FINAL PLAT
BROCK SECOND ADDITION
AN ADDITION TO WICHITA, SEDGWICK COUNTY, KANSAS

Re: S/D 96-74 - BROCK SECOND ADDITION (Final Plat)

CASE NUMBER: S/D 96-74 BROCK SECOND ADDITION

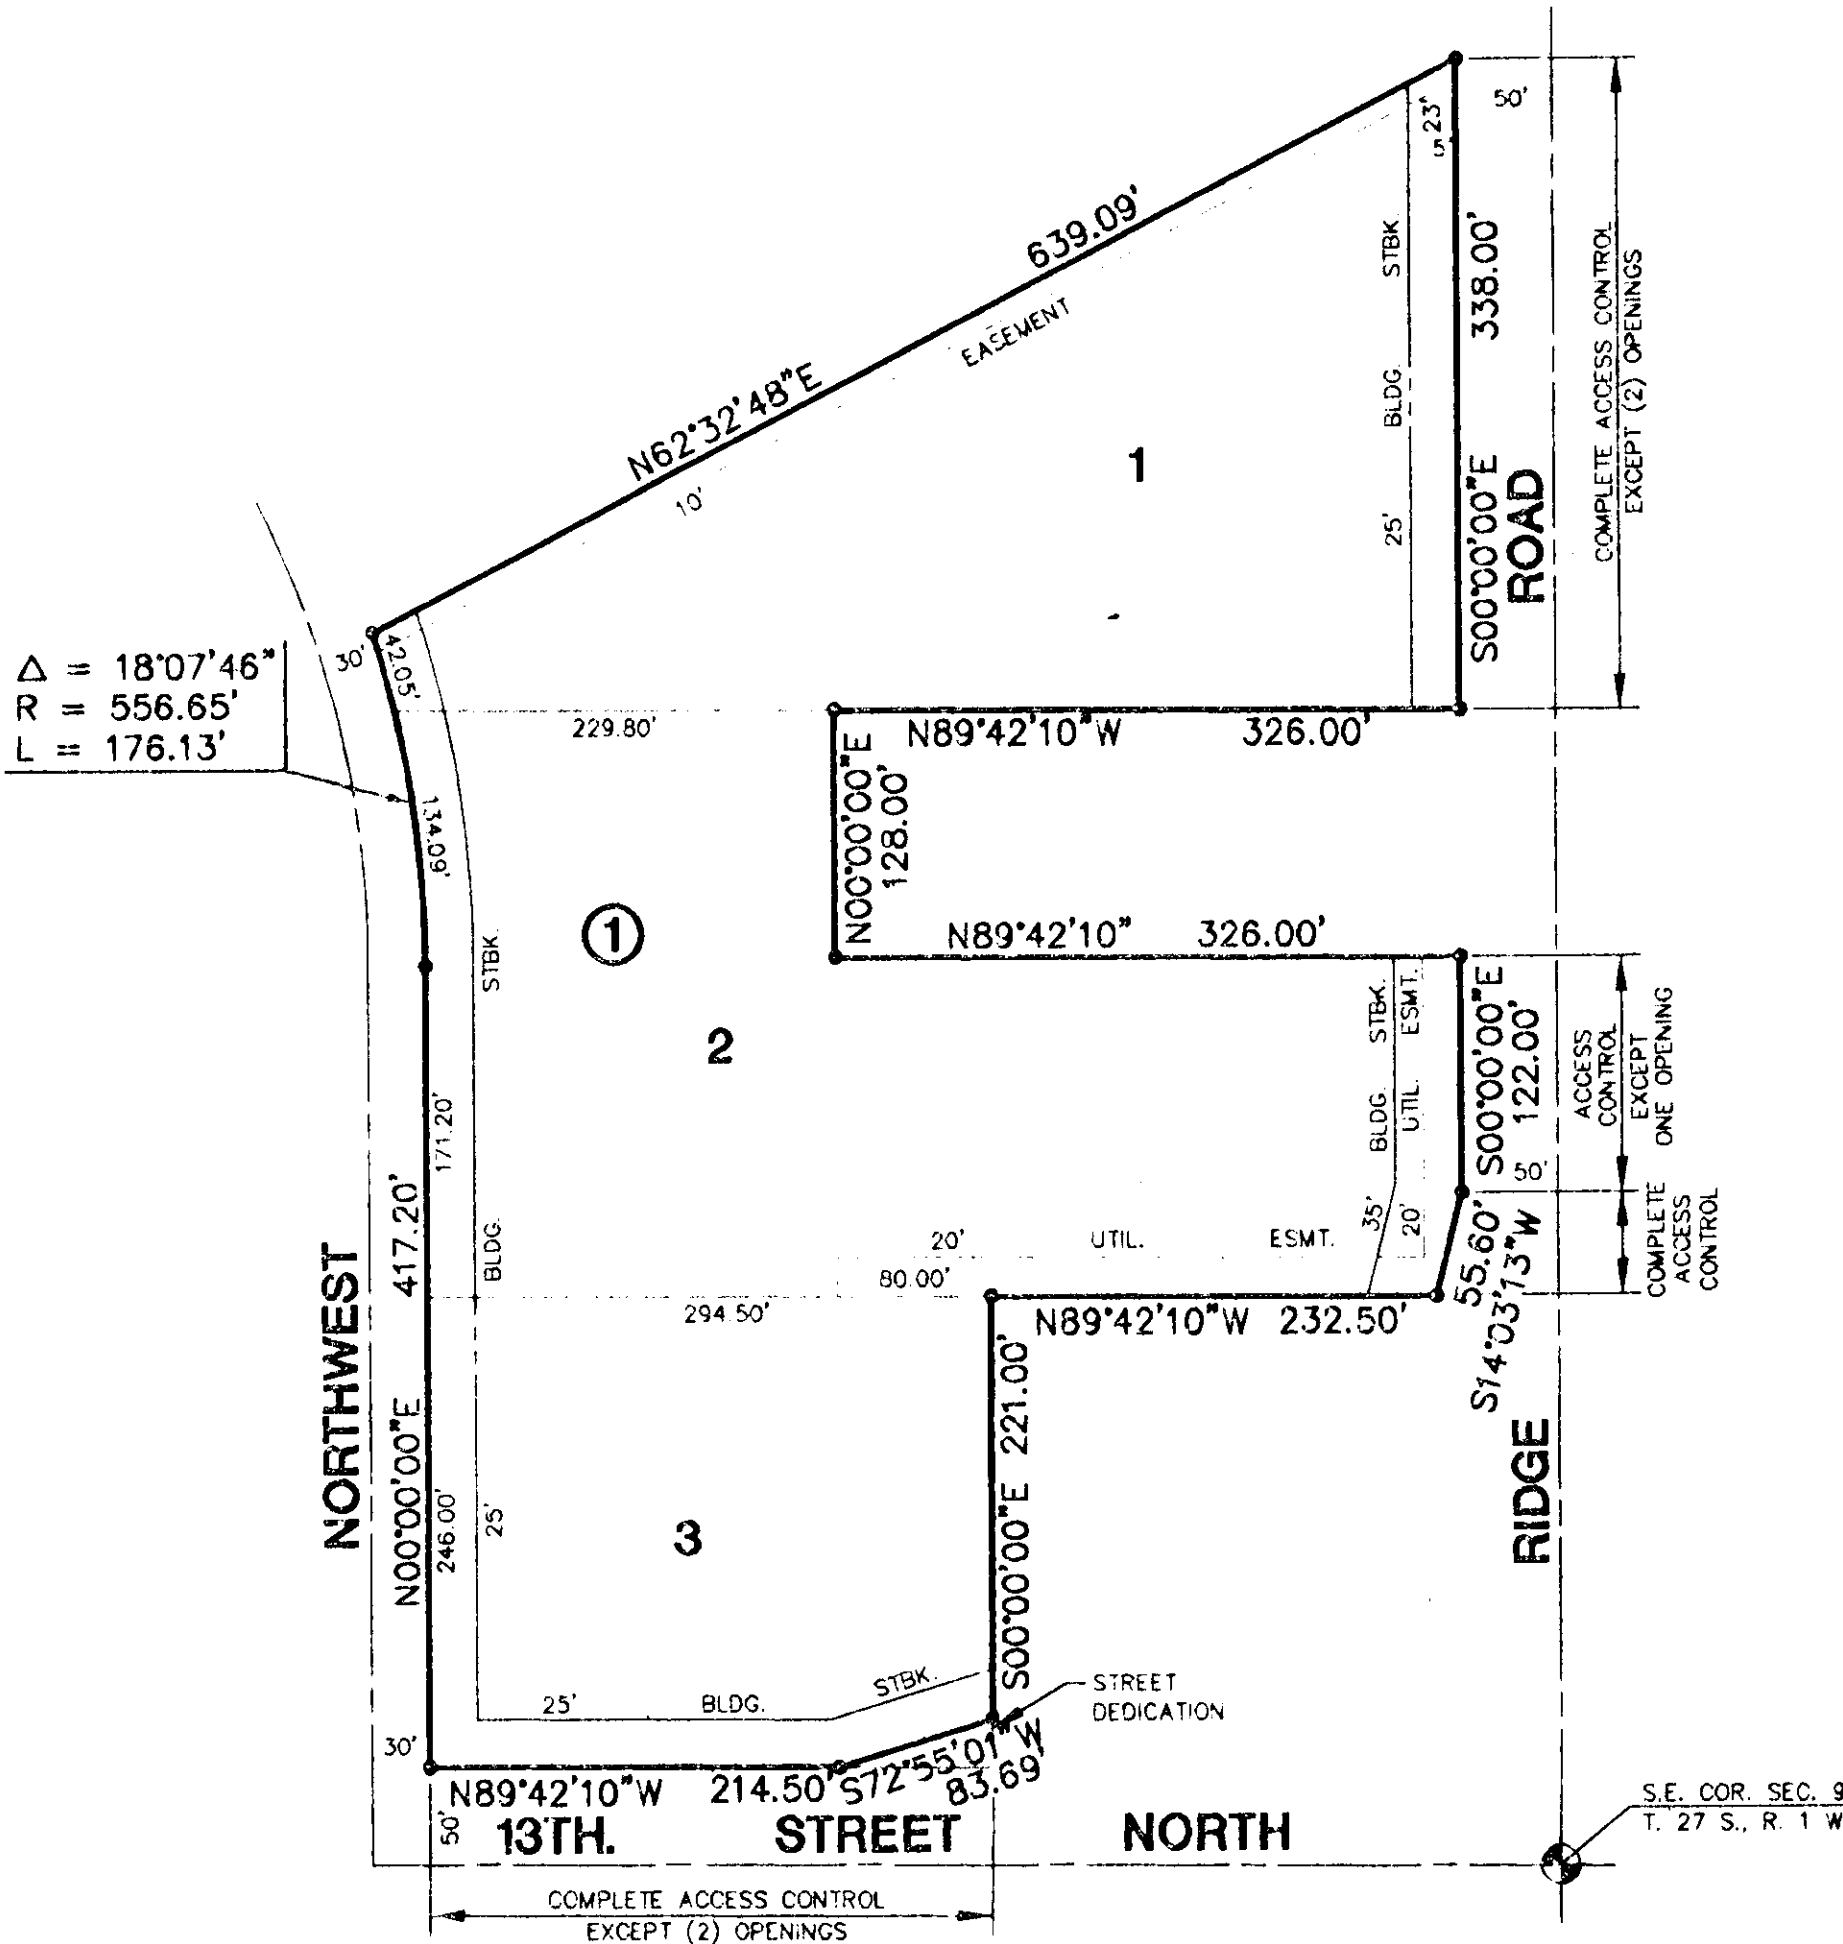
- A. At the time of site development, this property shall provide any needed drainage, including storm sewer, improvements.
- B. In regard to the final plat tracing, the applicant shall either:

Submit a 3-lot plat as proposed but with the dedication of complete access control to Northwest Parkway from the adjacent lots. Cross-lot access agreements for Lot 2 to use access through adjacent Lots 1 and 3 to Ridge Road and 13th Street North shall also be provided. For Lot 2, as required by the City's Fire Department, an emergency access easement shall be shown to Northwest Parkway and any related improvements shall be agreed to (curbing, gates, etc.). Any such easements shall be clearly indicated in the plat and shall be unencumbered by parking spaces or any other possible obstructions.

However, if the applicant is unable to secure cross-lot access agreements for Lot 2, from the adjoining property owners involved in this plat, a one-lot plat may be submitted for City Council approval. One "temporary" opening shall be allowed to Northwest Parkway in such case. The plat's text shall note in this case, that complete access control is contingently dedicated such that upon the future platting of these adjoining parcels, if cross-lot access is obtained at the time of such properties platting, that access to Northwest Parkway will be discontinued and that the existing opening will be converted to an emergency access opening only.

- C. Since an opening or openings is to be provided for Lots 1 and 3 to the adjacent streets, the word "complete" shall be deleted from those areas where access is being provided.

- D. On the final plat tracing additional information shall be shown in regard to this plat's tie point. Specifically, a dimension should be indicated from the Southeast corner of Section 9 to one of the plat's corners and/or a tie point also indicated to an existing lot.

- E. On the final plat tracing, an appropriate title should be indicated for Mark Stanford of Cooperstown, Inc. on the platlor's signature line.
- F. On the final plat, the MAPC Chairman shall be indicated as John C. Frye.

- H. The applicant's engineer is advised that the Register of Deeds is requiring the name(s) of the notary public, who acknowledges the signatures on this plat, to be printed beneath the notary's signature.

- I. Perimeter closure computations shall be submitted with the final plat tracing. Section 5-101(c).
- J. Recording of the plat within 30 days after approval by the City Council and/or County Commission.
